Access Compliance Report Public Rights-of-Way (Island Curb Cuts)

Main Street: CHIQUITA_CANYON_DR		Cross Street: CHIQUITA_CANYON_DR		Location:	S
ADA ID: CCRK211124131450	Curb Cut Type: MedianRefuge2	Initial Pass/Fail: Fail	Overall Compliance: No	Severity Score:	15
Codes/Mitigation Info/Possible Solution			Field Measurements/Component Compliance

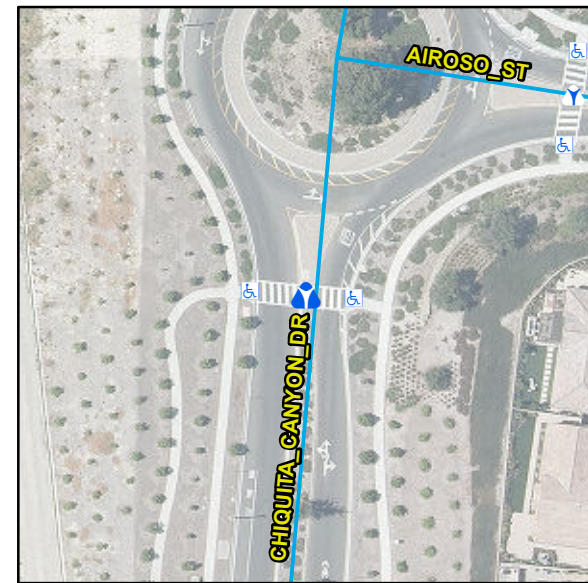
Compliance	Description	Data	Compliance	Description	Data
Yes	Refuge 1 Length (In)	42	N/A	Guttter 1 Ponding	N/A
Yes	Refuge 1 Width (In)	96	Yes	Gutter 1 Lip Ht (In)	0
No	Refuge 1 Slope (%)	5.7	N/A	Gutter 1 Slope (%)	N/A
Yes	Refuge 1 Cross Slope (%)	4.3	N/A	Gutter 1 Cross Slope (%)	N/A
N/A	Painted Cross Walk 1	Yes	N/A	DWS 1 Provided	N/A
	Cross Walk 1 Direction	W	N/A	DWS 1 Contrast	N/A
	Cross Walk 1 Width (In)	150	N/A	DWS 1 Length (In)	N/A
Yes	Refuge Inside Cross Walk 1	Yes	N/A	DWS 1 Full Width	N/A
	Road 1 Slope (%)	2.3	N/A	DWS 1 Offset (In)	N/A
	Road 1 Cross Slope (%)	1.8			N/A
Yes	Refuge 2 Length (In)	42	N/A	Guttter 2 Ponding	N/A
Yes	Refuge 2 Width (In)	96	Yes	Gutter 2 Lip Ht (In)	0
No	Refuge 2 Slope (%)	5.1	N/A	Gutter 2 Slope (%)	N/A
Yes	Refuge 2 Cross Slope (%)	4	N/A	Gutter 2 Cross Slope (%)	N/A
N/A	Painted Cross Walk 2	Yes	N/A	DWS 2 Provided	N/A
	Cross Walk 2 Direction	E	N/A	DWS 2 Contrast	N/A
	Cross Walk 2 Width (In)	150	N/A	DWS 2 Length (In)	N/A

Remove & Replace Entire Refuge.
